INDESIT company

Model type:
TA5FNFPS

Commercial code:
F032240

RE0200T0 (... - 61016...) Exploded views

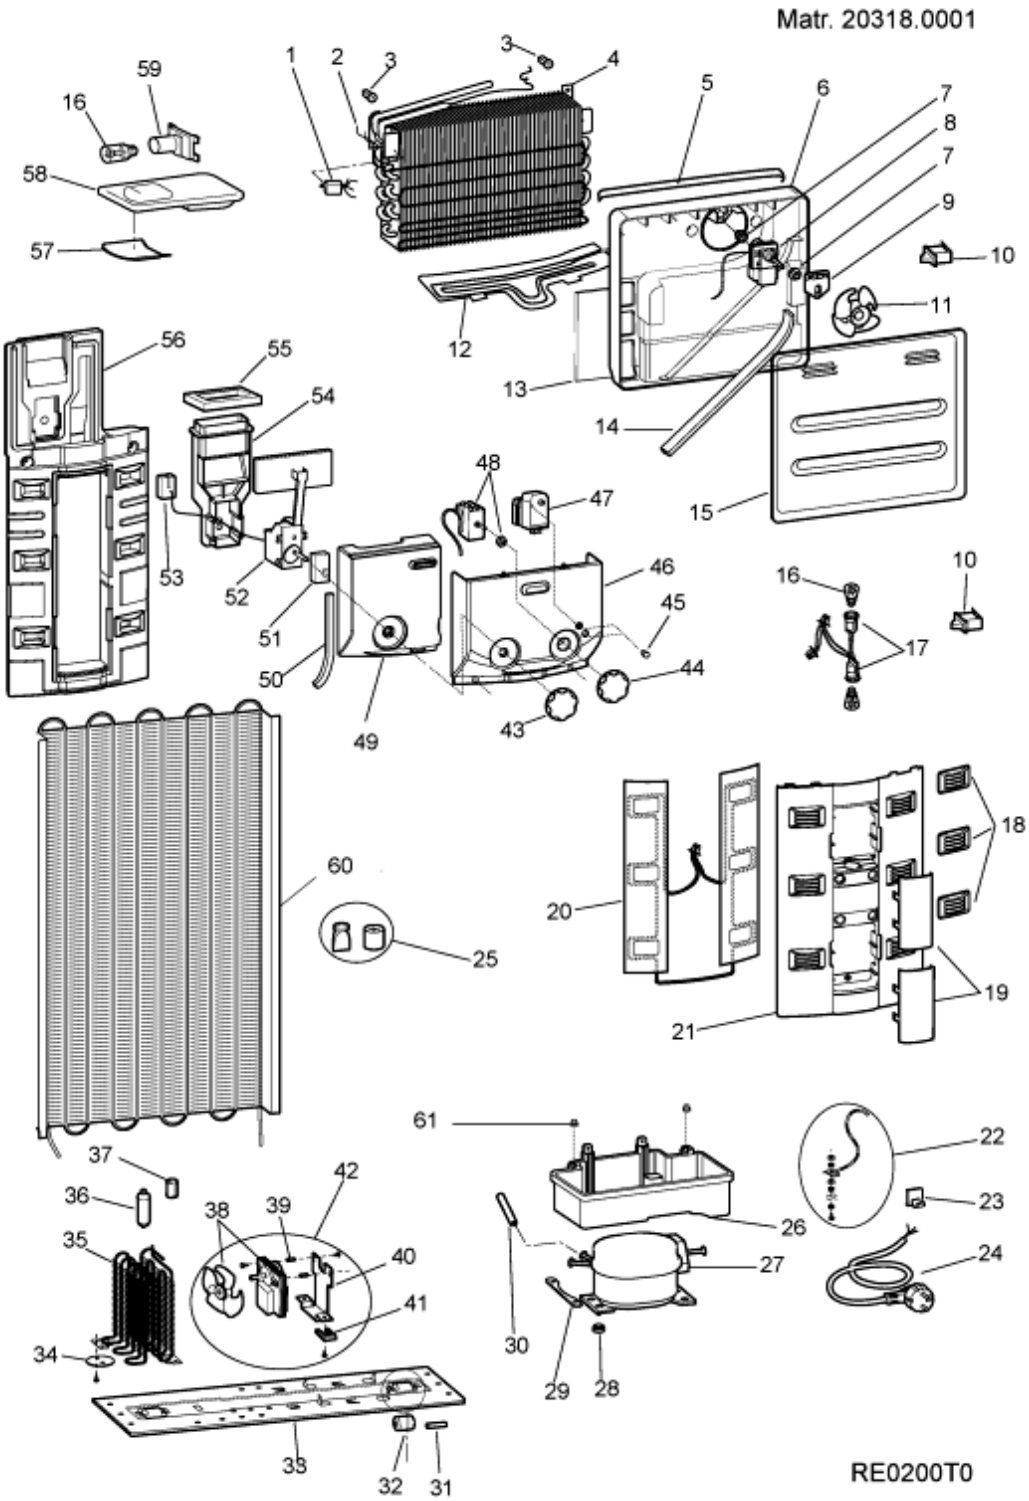
0999360: modification on freezer fan motor

Since 01 July 2004 freezer fan motor has been modified to reduce noise level on no frost models that are produced in Manisa plant. (Old fan motor has grey cover, new fan motor has light green cover.) Spare part code remains the same. If you replace the old fan motor with the new fan motor, rubber for fan has to be replaced with the new one and sponge should not be used with the new fan motor.

0999369: FAN MOTOR MODIFICATION FOR DECREASING NOISE LEVEL

From serial number 50625.0001 on electronic no-frost models and from serial number 50723.0001 on mechanic no-frost models freezer fan motor has been modified for decreasing noise level.

Modified parts:
139648 - fan motor
119866 - fin evap cover assembly
140463 - freezer rear cover assembly
140462 - fast feezer cover
140662 - damper styrofoam (eps)
140661 - multiflow upper cover
140663 - multiflow styrofoam (eps)

Premodified parts:
174380 - fan motor
173745 - fin evap cover assembly
174886 - freezer rear cover assembly
174992 - fast freezer cover
174943 - damper styrofoam (eps)
090287 - multiflow upper cover
174944 - multiflow styrofoam (eps)

Since RPM of the new motor is lower than the previous one, new fan motor is not interchangeable with the old one, and it cannot be used on the premodified appliances.

0999377: compressor basement modification

Since 13/10/2005 compressor basement 174281 has been used instead of 089676 on no-frost models which are produced with Tecumseh compressor.

RE0247T0 (... - 61016...) Exploded views

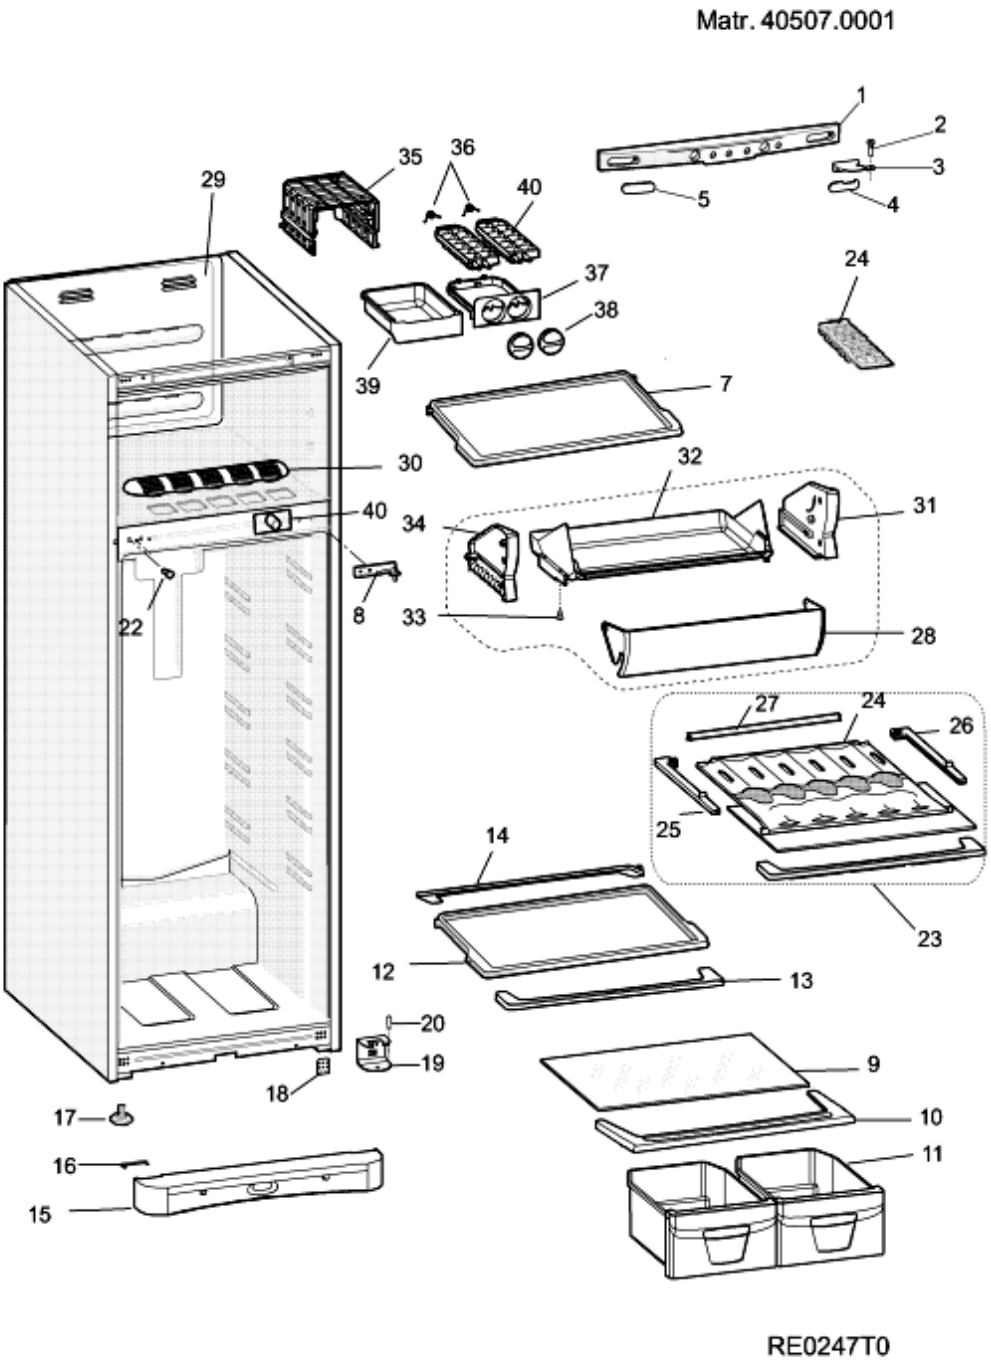
0999357: plastic compressor basement

Plastic compressor basement will be used on refrigerators since this reason adjutable foot and except single door bottom hinge have been changed. New hinge will be managed with a new code. The new bottom hinge can be used on both left and right sides.

New adjustable foot;
89682- white
89686- black

New bottom hinge assembley with adjustable foot;
110081- white
110522 - black

0999363: lamp switch has been moved to middle panel of cabinet

Since 10/10/04 lamp switch has been moved from inner side of foamed cabinet to outer middle panel of cabinet on electronic no-frost models which is used R600
114542- lamp switch
